EL MONTE UNION HIGH SCHOOL DISTRICT

April 14, 2023

TO : All Bidders
FROM : El Monte Union High School District
BID # : 2022-23(B8)
PROJECT : Mountain View HS Modernization Project
SUBJECT : Addendum No. 2

1. LPA Architects Addendum No. A issued April 14, 2023 attached.

MATERIALS
PLAN

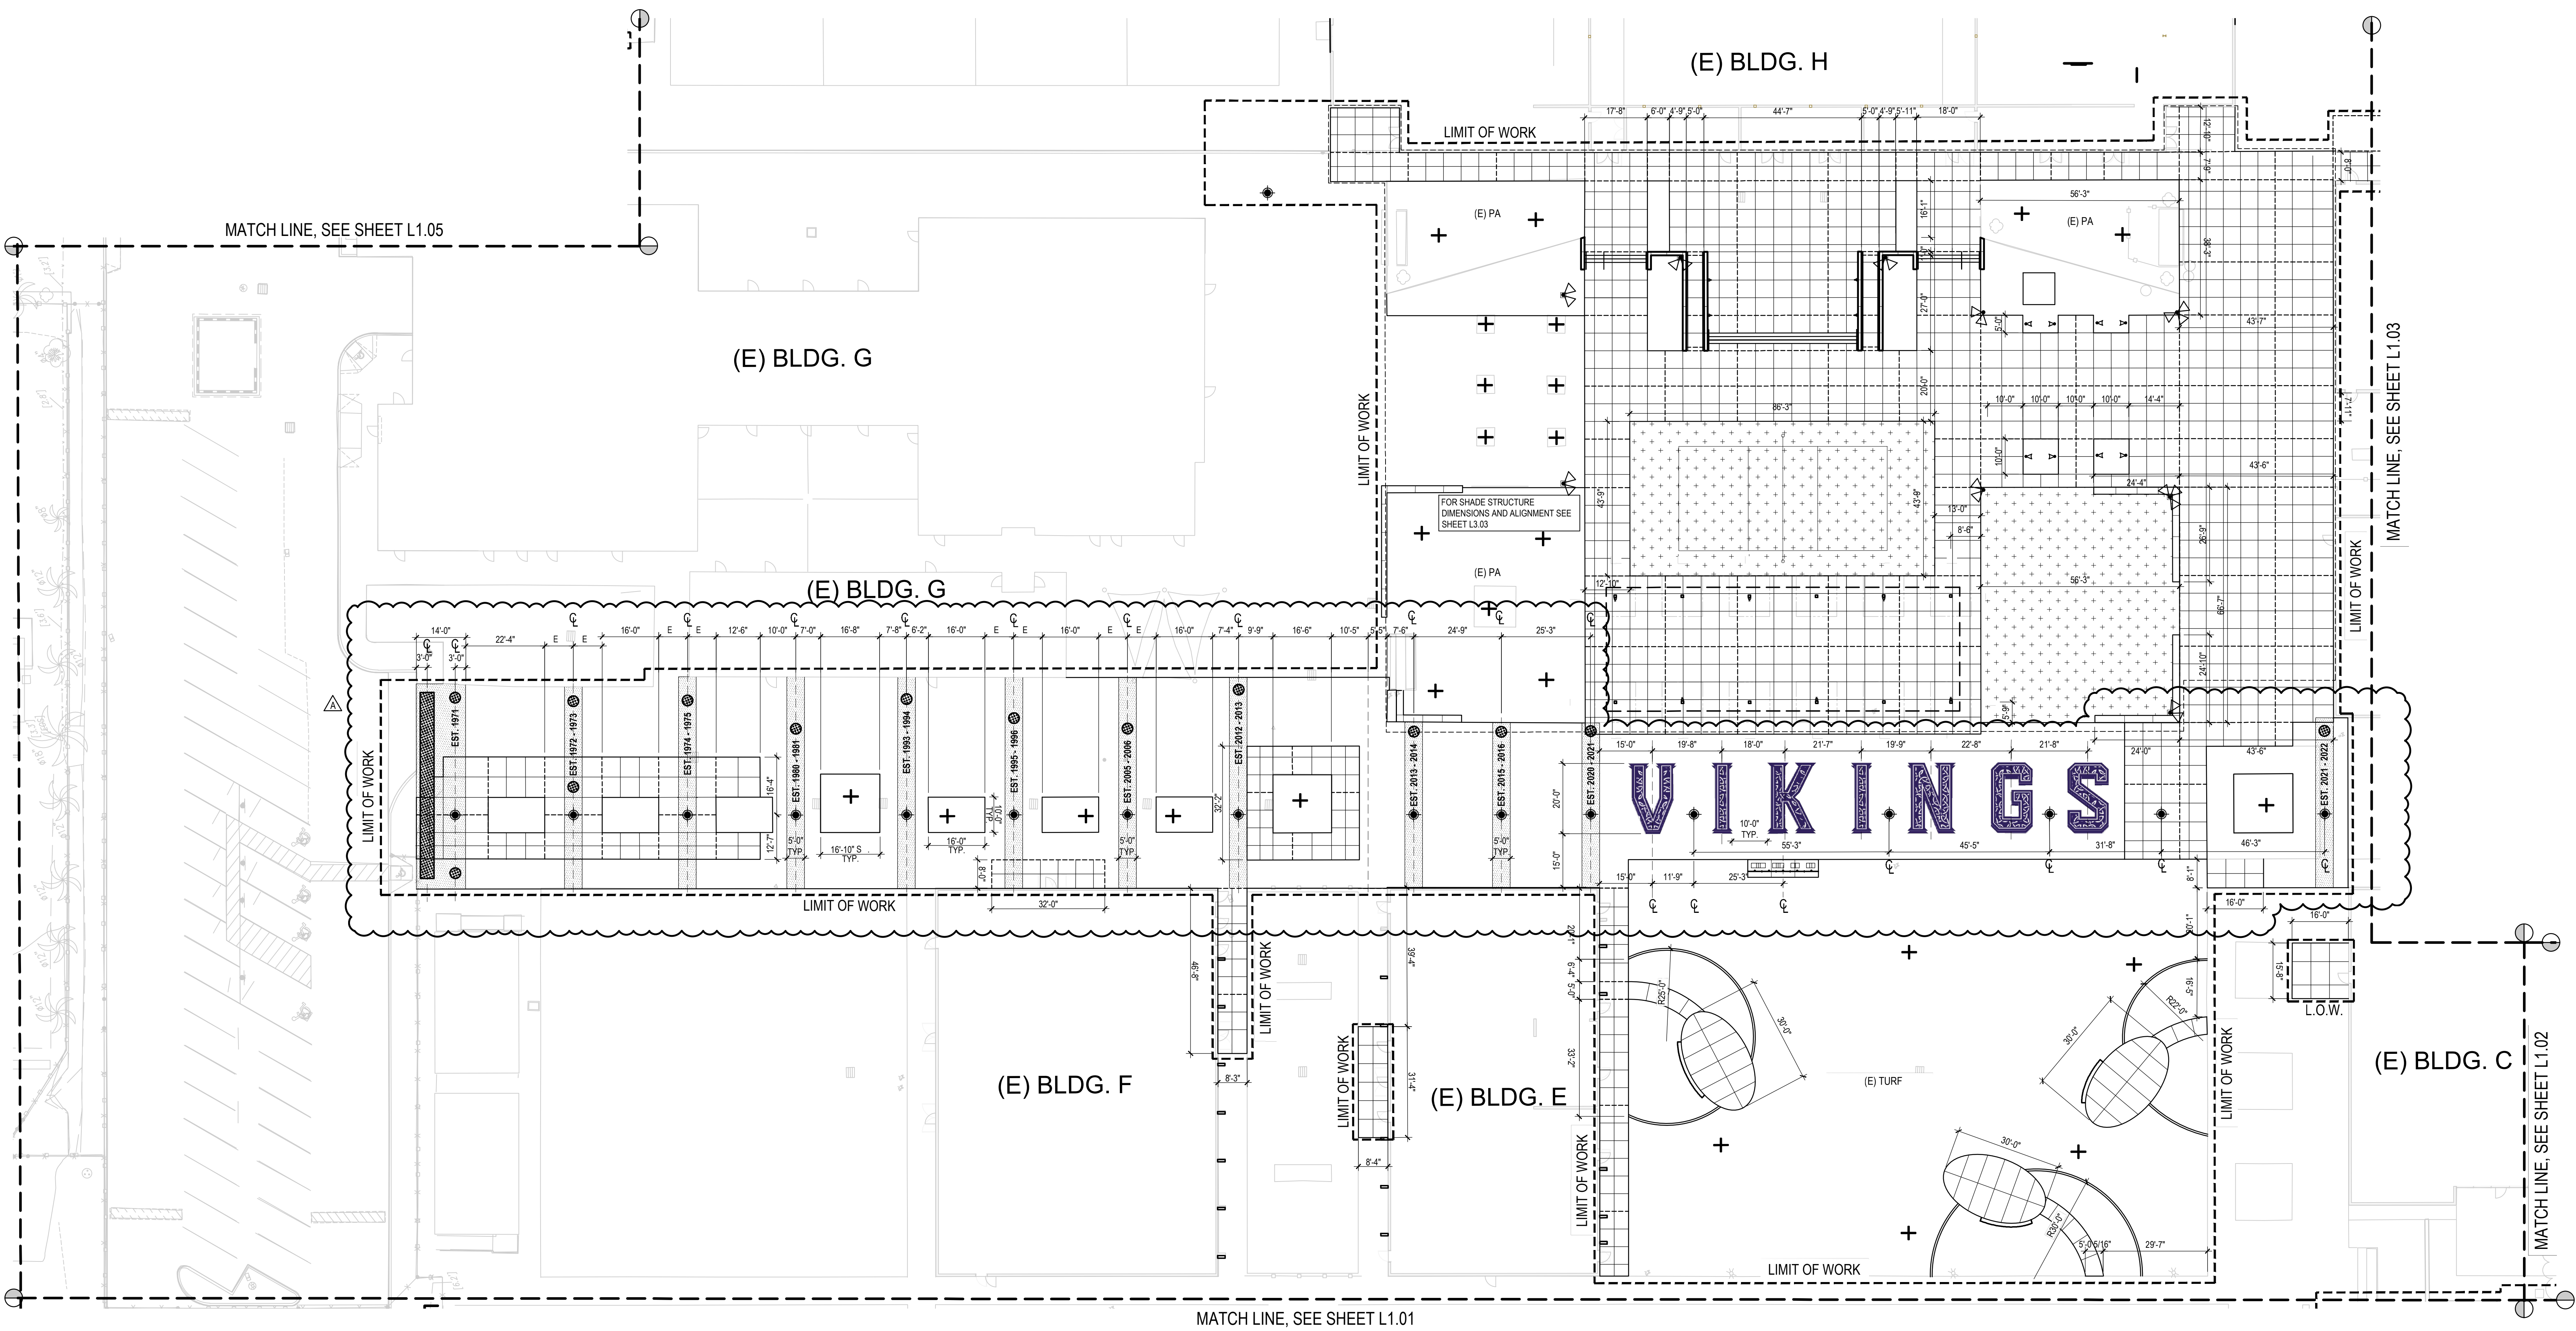
- Item No. 12** **Sheet L1.04 – Materials Plan**
(a) Painted striping, 'Vikings' lettering, and logos added on Victory Walk paving south of Building G.
(b) Keynote 'G' added.

(c) Keynote '40' in legend updated.
- Item No. 13** **Sheet L2.04 – Layout Plan**
(a) Painted striping, 'Vikings' lettering, and logos added on Victory Walk paving south of Building G.

INTEGRAL GUTTER 3" = 1'-0" 12

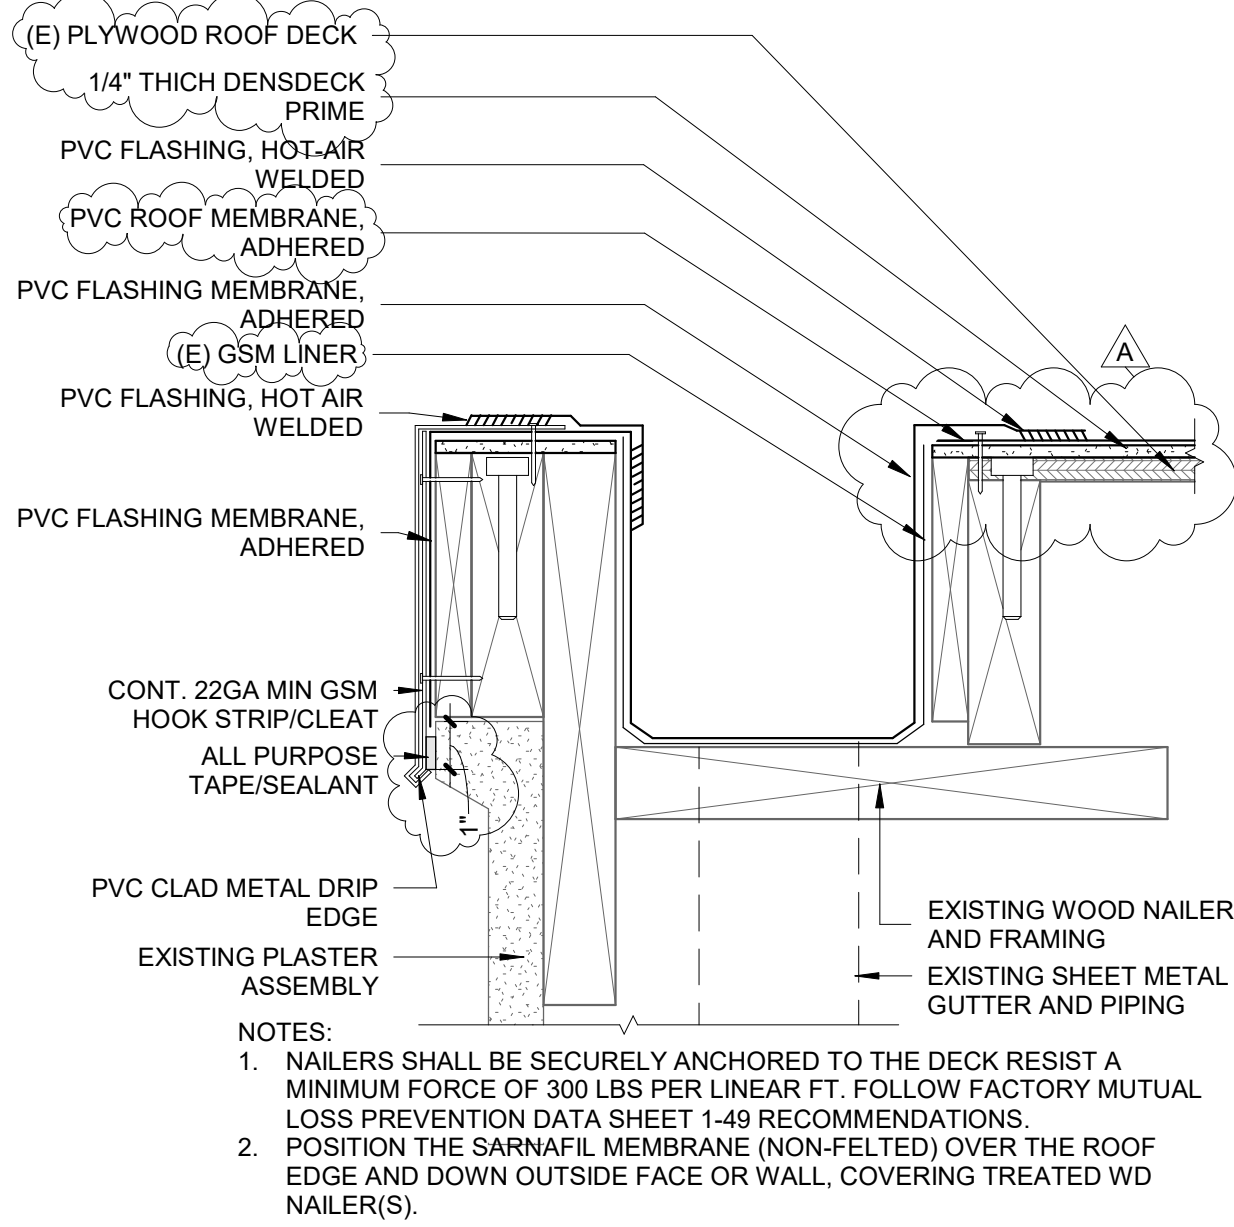
(a) New Detail 11: Added detail for flashing under screen wall.
(b) Detail 12: Added notes clarifying existing elements and new densdeck prime.
- Item No. 29** **Sheet A9.22 – Ceiling Details**

SOLATUBE SECTION 1 1/2" = 1'-0" 11

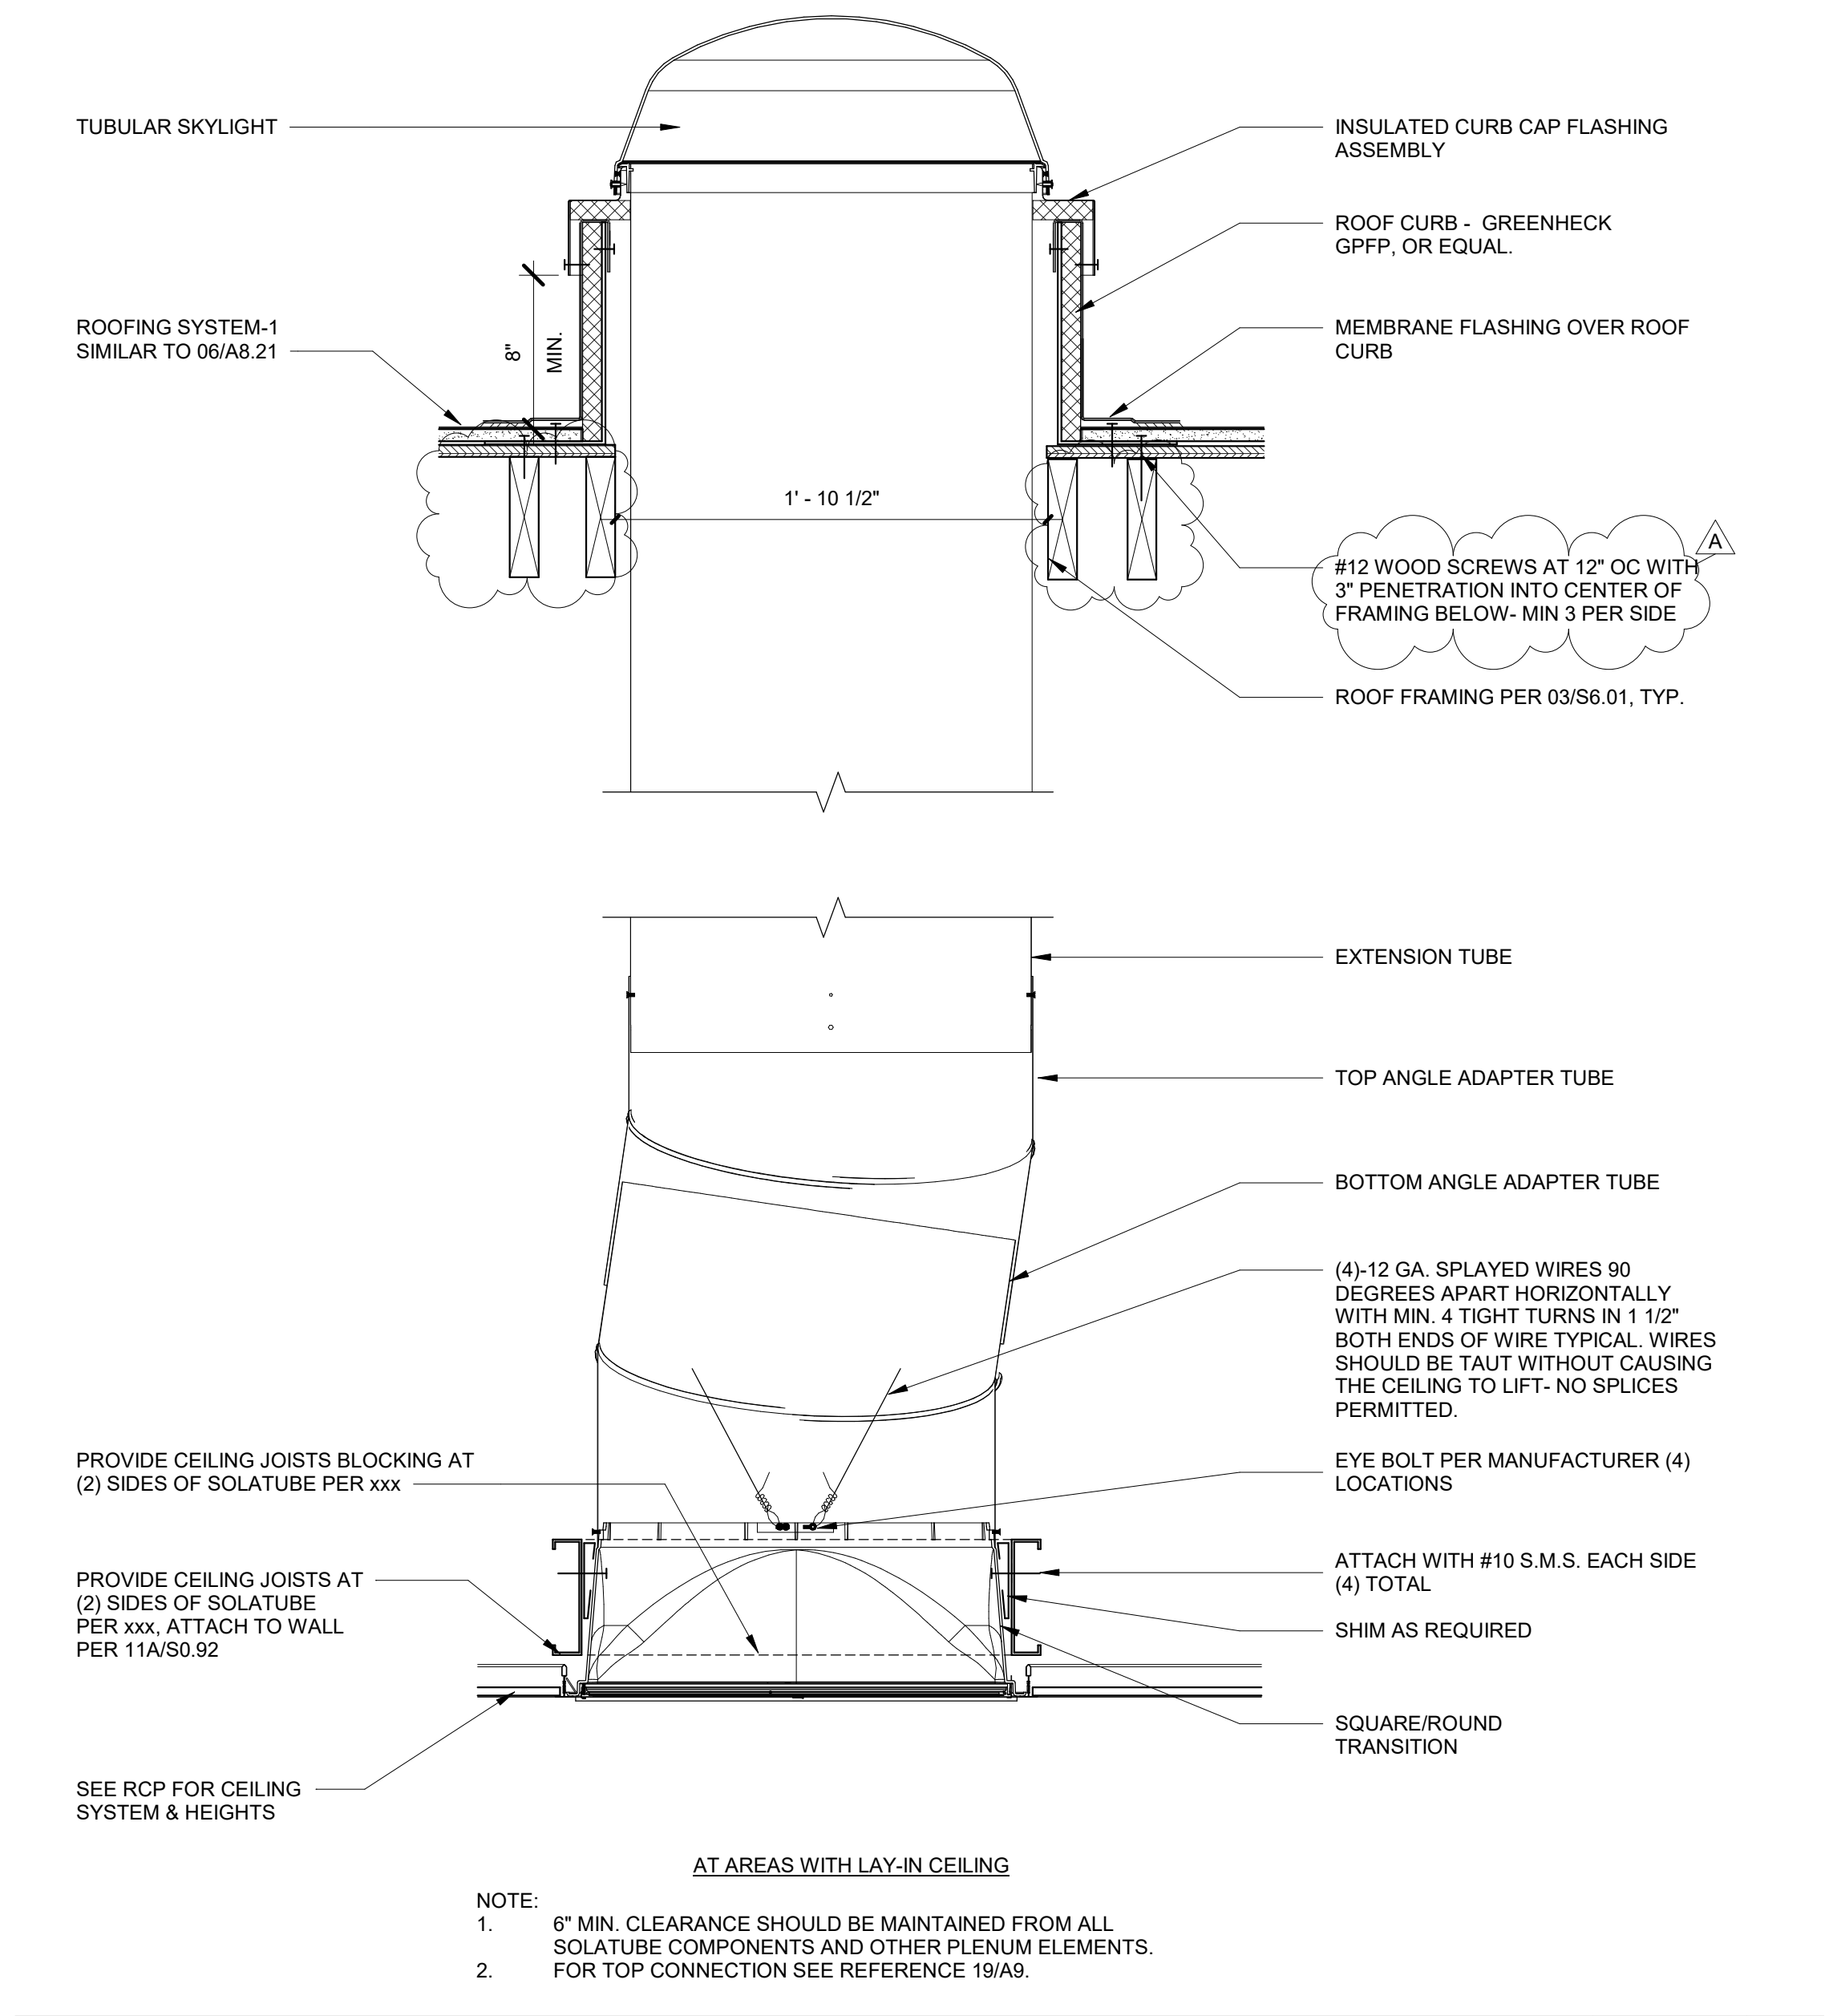
(a) Detail 11: Revised metal deck to wood framing. Updated associated fastener note.
- Item No. 30** **Sheet A9.31 – Casework Details**
(a) Detail 23 revised to include recessed heavy duty adjustable shelf supports with shelf clips
